**TOWN OF LOS GATOS
PLANNING COMMISSION AGENDA
OCTOBER 09, 2019
110 EAST MAIN STREET
LOS GATOS, CA**

**TOWN OF LOS GATOS
PLANNING COMMISSION AGENDA
OCTOBER 09, 2019
7:00 PM**

SUBJECT: Architecture and Site Application S-18-050. Project Location: **56 Central Avenue**. Property Owner: Andrew and Ashley Bothman. Applicant: Rick Hartman, HOMETEC Architecture. Appellant: Leslie Morley. Project Planner: Jocelyn Shoopman.

1 PROPOSED FIRST FLOOR PLAN
Scale: 1/16"=1'-0"
June 21st 9:00am
December 21st 9:00am

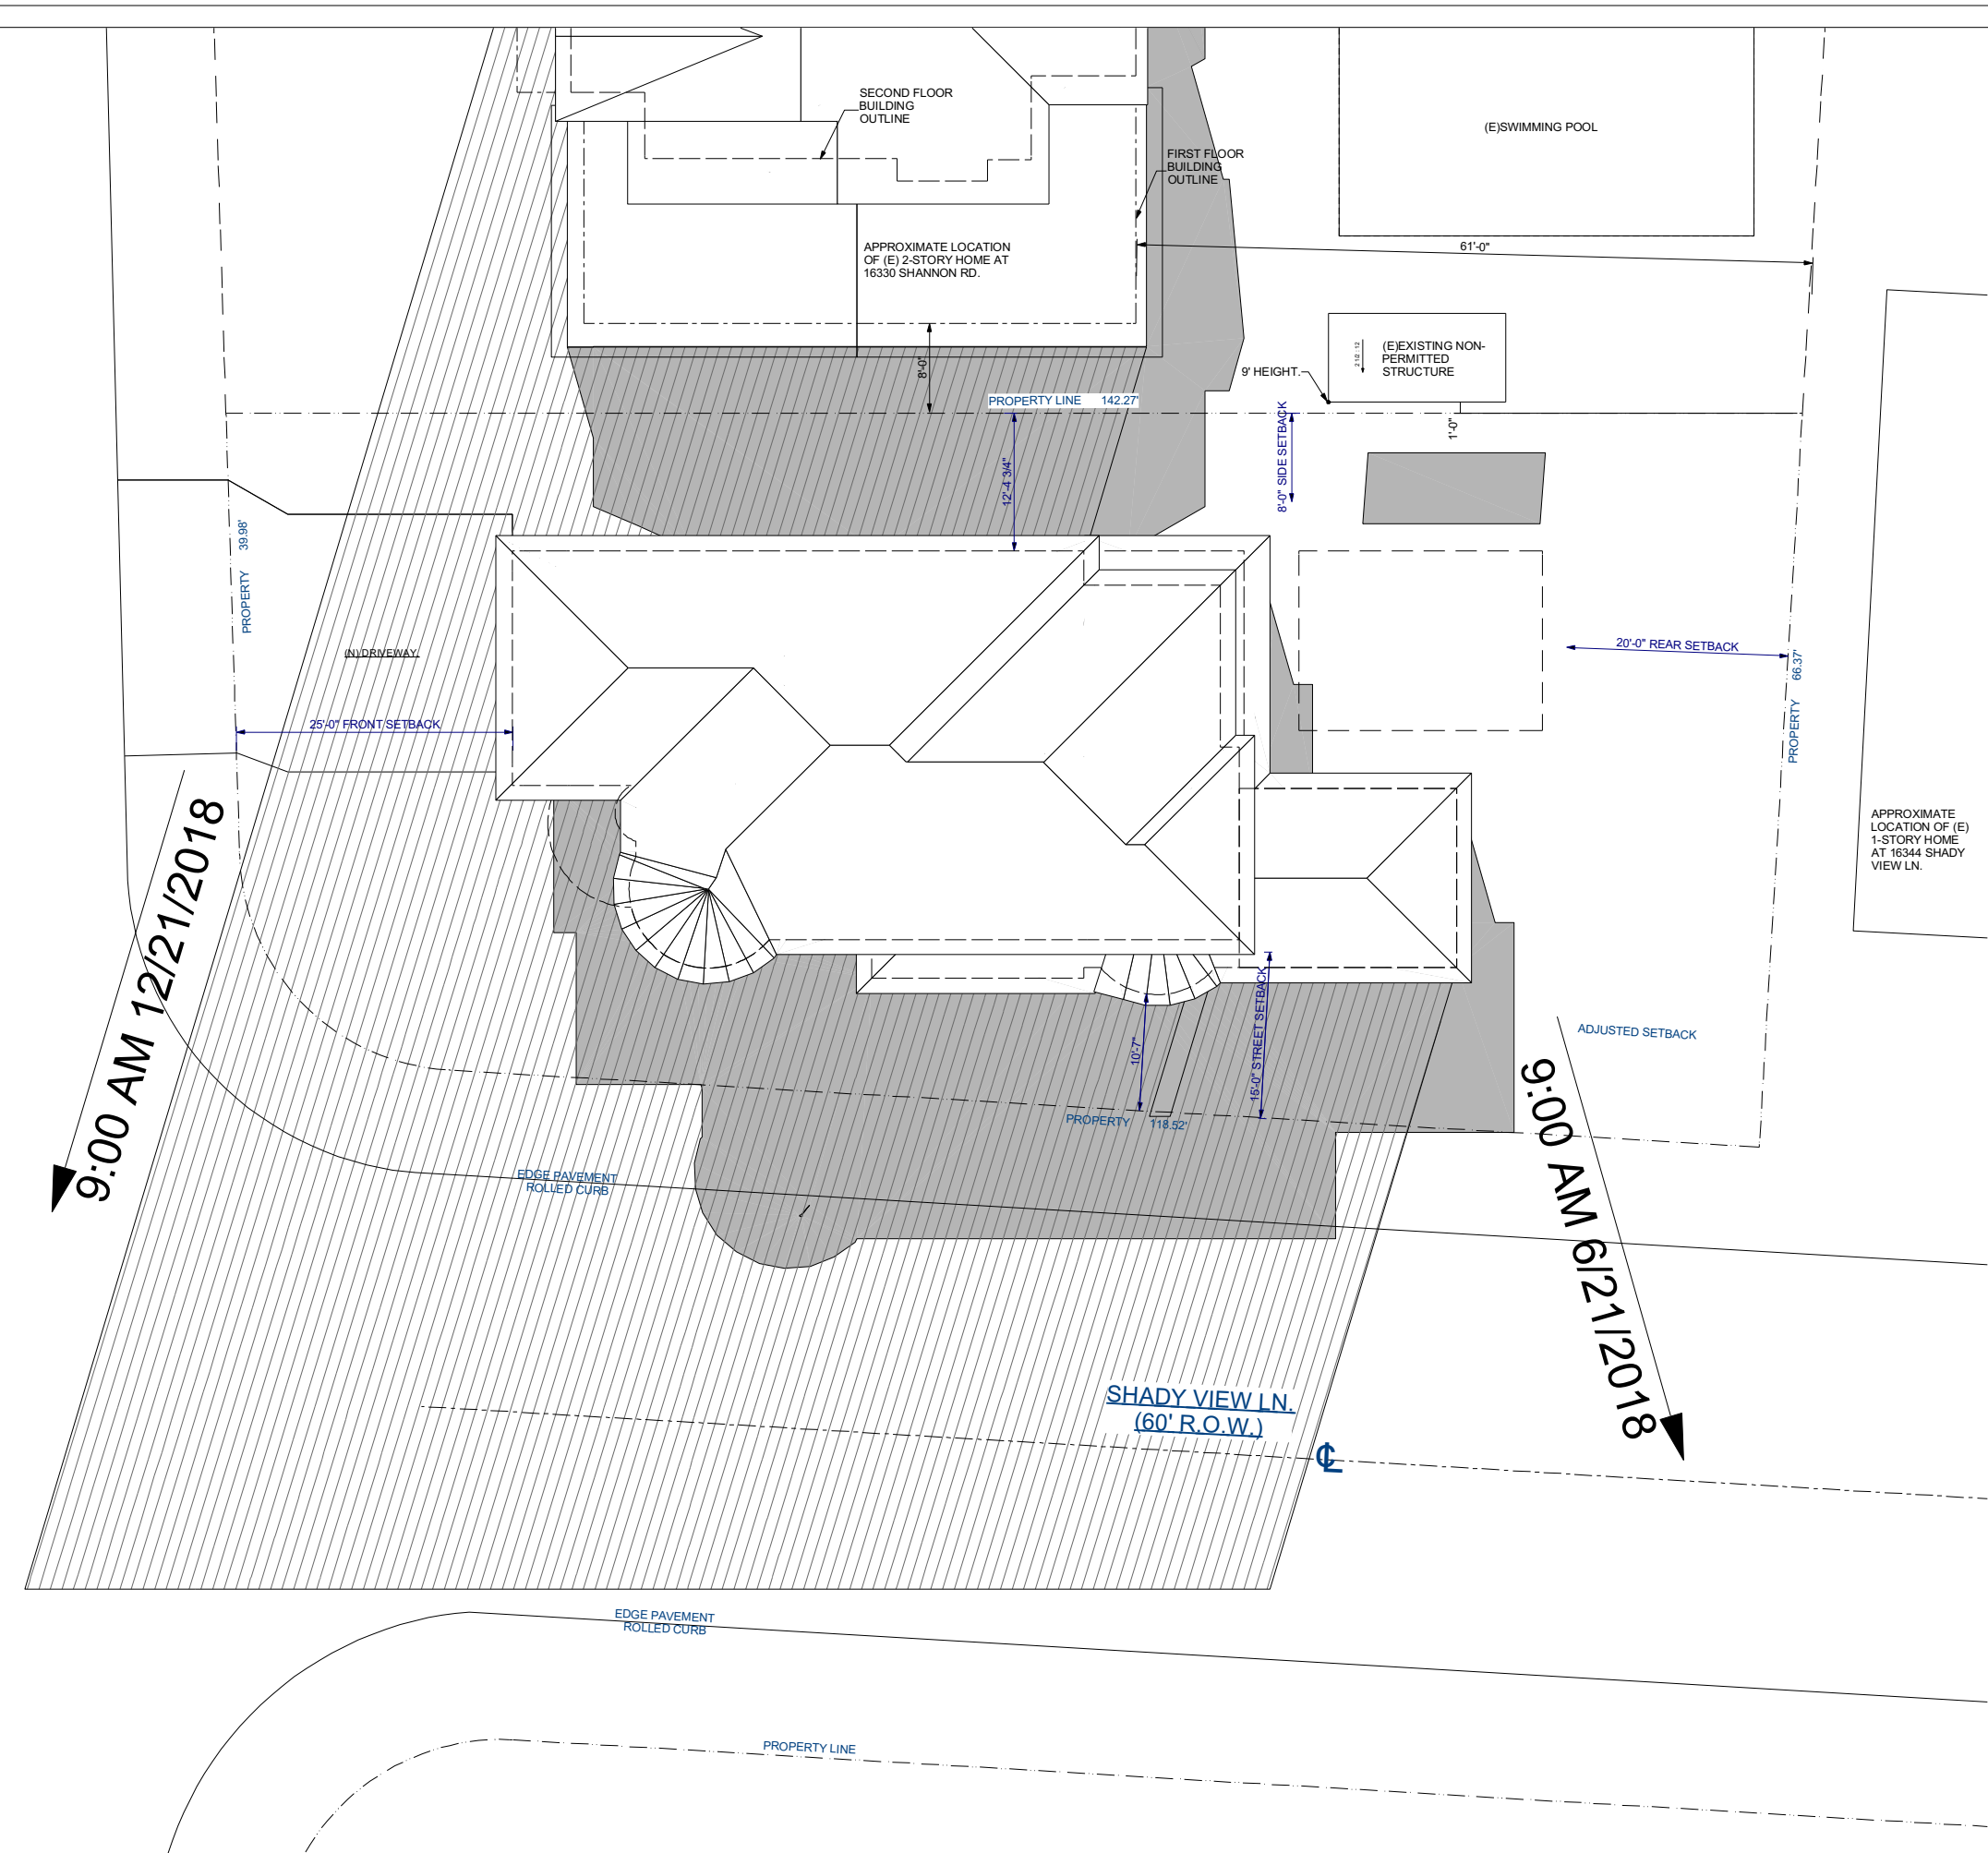
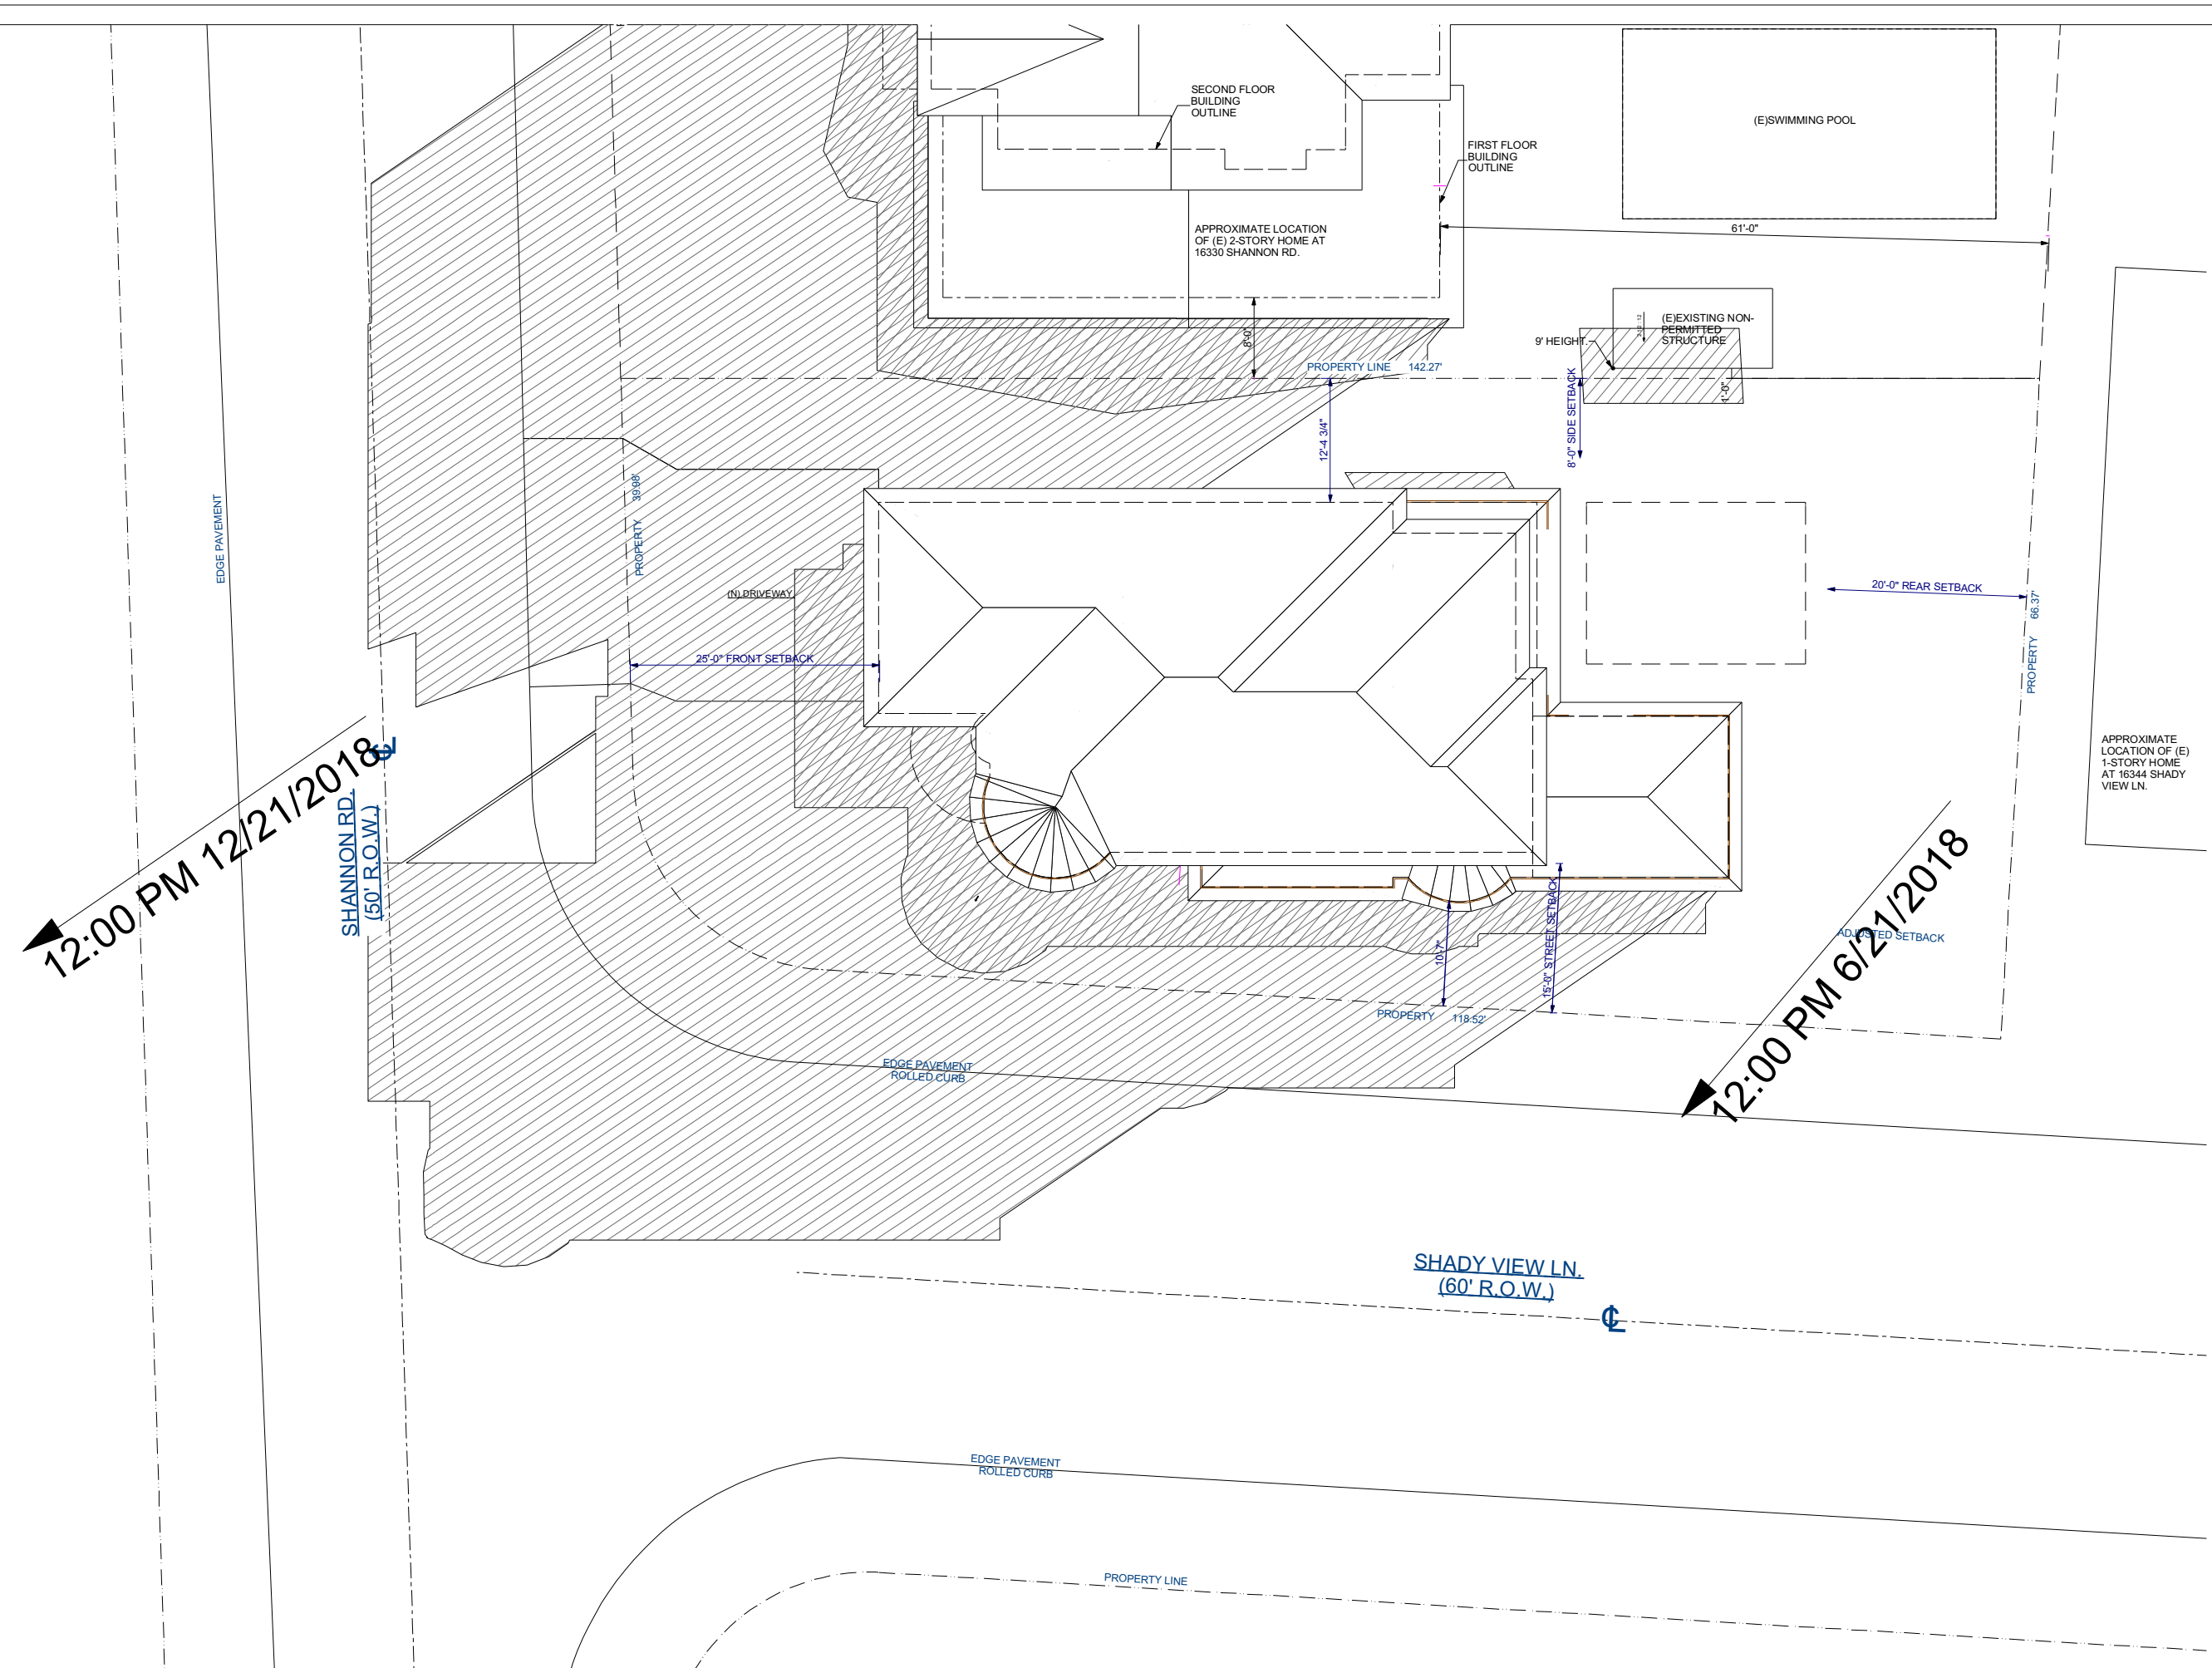
My review letter for this project identified a concern that the project's proposed second floor eave height would be substantially higher than that of the adjacent home at 16330 Shannon Road. I later received a revised drawing sheet A6.3, noted as "*Planning Set 7/9/2019*", which showed the adjacent home's height corrected to its actual height which is 29 feet - over three and a half feet taller than shown on the previous drawing used for the review. That review letter comment is therefore no longer applicable since the maximum roof height for new proposed new home at 16336 Shady View Lane height is 28'-7" which is is comparable to the adjacent existing home.
